- 2. Hangar Subdivision; KPB File 2025-086**  
**McLane Consulting Group / Sterling TB Realty, LLC**  
**Location: MP 84.25 Sterling Highway**  
**Sterling Area**

**ITEM #2 - PRELIMINARY PLAT  
HANGAR SUBDIVISION**

<b>KPB File No.</b>	2025-086
<b>Plat Committee Meeting:</b>	June 23, 2025
<b>Applicant / Owner:</b>	Sterling TB Realty LLC of Fort Worth, Texas
<b>Surveyor:</b>	Andrew Hamilton / McLane Consulting, Inc.
<b>General Location:</b>	Scout Lake Area

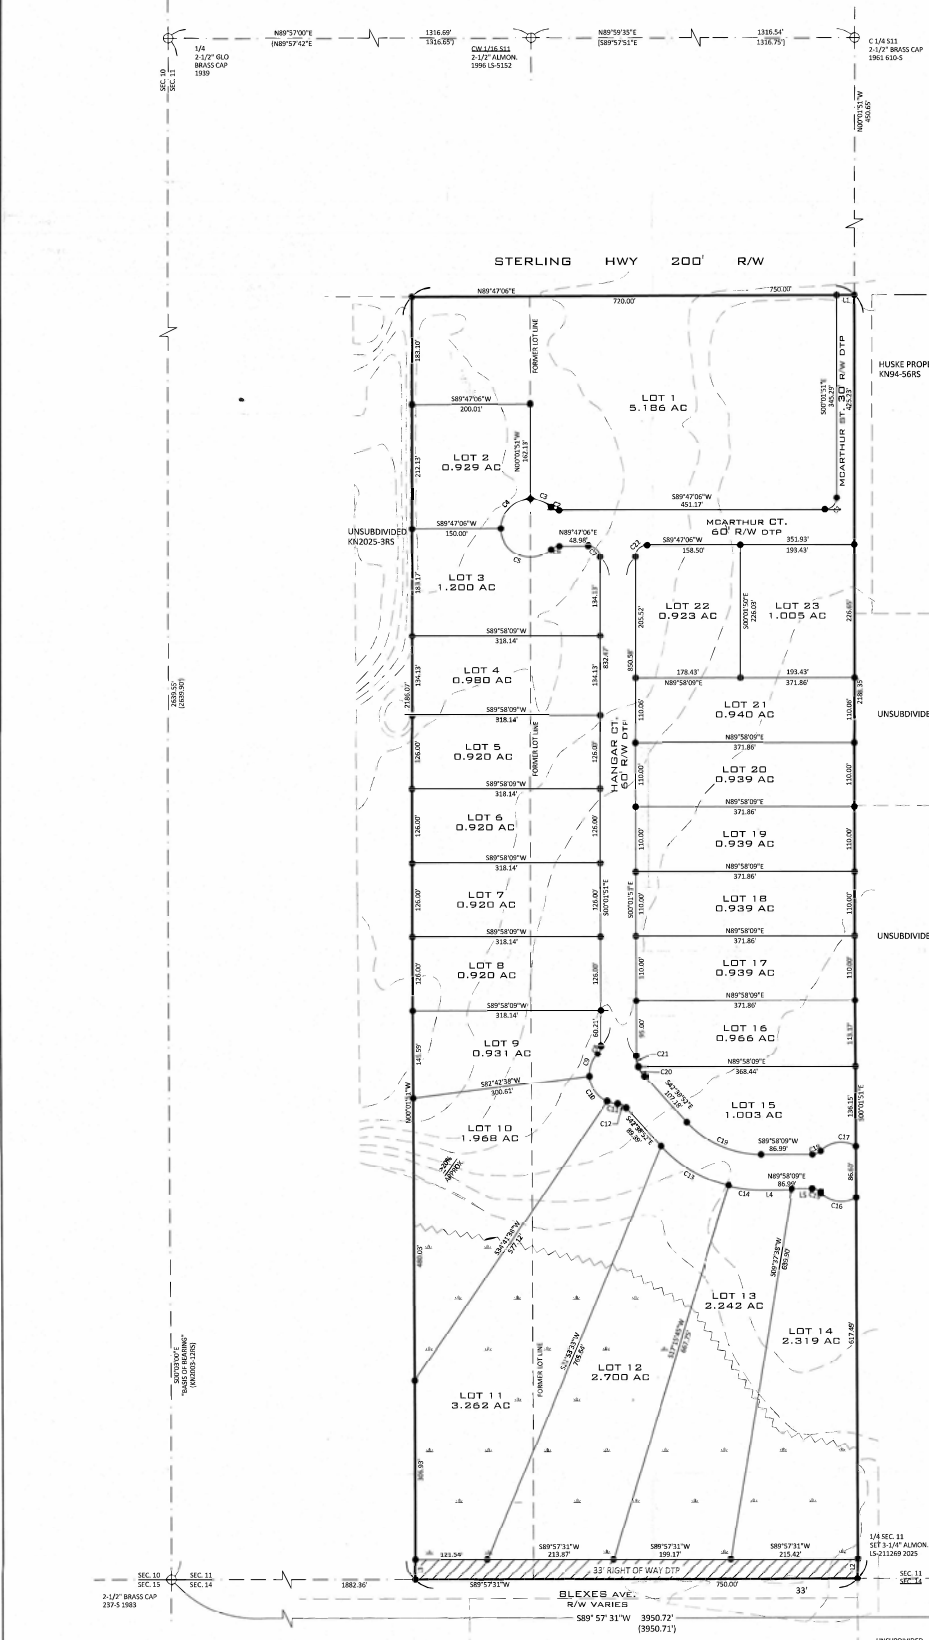
The plat is affected by a section line easement, 33-feet on either side of the section line to the south, located within Blexes Avenue. **Staff recommends** the surveyor depict and label the section line easement within the right-of-way and extending to the east and west.

Steep topography affects the proposed platting area according to the KPB GIS Imagery Terrain Layer. Areas greater than 20% have been labeled on the preliminary plat. **Staff recommends** it is the surveyor's discretion to keep or remove the contours and keep the top and toe of bluff on the final plat per KPB 20.60.010.

The KPB River Center Reviewer has identified the proposed plat to be within a FEMA non-regulatory flood hazard area, Zone X. **Staff recommends** the surveyor include the Flood Hazard Notice per KPB 20.30.280 and include the zone and map panel.

A soils report will be required for Lots 2 through 23 and an engineer will sign the final plat as the new lots are less than 200,000 square feet. A soils report will not be required for Lot 1 as the new lot is greater than 200,000 square feet (225,902.16). **Staff recommends** the surveyor modify the Waste Water Disposal Note as needed once the Soils Report has been completed in order to comply with KPB 20.40. Current wastewater disposal note does not match the note as shown in 20.40.040 and needs to be updated.

A general easement is granted to Homer Electric Association, Inc., as recorded in Book 4, Page 117, KRD, that affects this subdivision. **Staff recommends** the surveyor include a plat note referencing the easement as found in the CTP item number 12.

- Update the Wastewater Disposal note to current code as shown in KPB 20.40.040 or as determined by soils report.
- McArthur St on the east side of the plat should be matched for right-of-way with a dedication
- Modify the KPB File No to 2025-086
- Plat note 6 needs the other exceptions granted to be added.

- No access to state maintained rights-of-way permitted unless approved by the State of Alaska Department of Transportation.
- Per DOT The platting action voids any previous issued permits. Land owners will need to reapply for driveway access permits to state road and right-of-way access.

- C. The location, width, and name of existing or platted streets and public ways, railroad rights-of-way, and other important features such as section lines or political subdivisions or municipal corporation boundaries abutting the subdivision;  
**Staff recommendation:**
- A 66-foot section line easement is located to the south- 33-feet on either side of the section line, label the SLE
- D. A vicinity map, drawn to scale showing location of proposed subdivision, north arrow if different from plat orientation, township and range, section lines, roads, political boundaries, and prominent natural and manmade features, such as shorelines or streams;

- Label: Robinson Loop Road, Scout Lake Loop Road and Swanson River Road

- Add CTP #10

- Add CTP #12
- Depict and Label SLE
- McArthur St to the east needs a matching right-of-way from this side of the line the entire length.

Add reference to the plat waiver and recording on the two properties to the east.and one to the southeast

Wastewater disposal notes should match as written in code.

- add Blexes Court
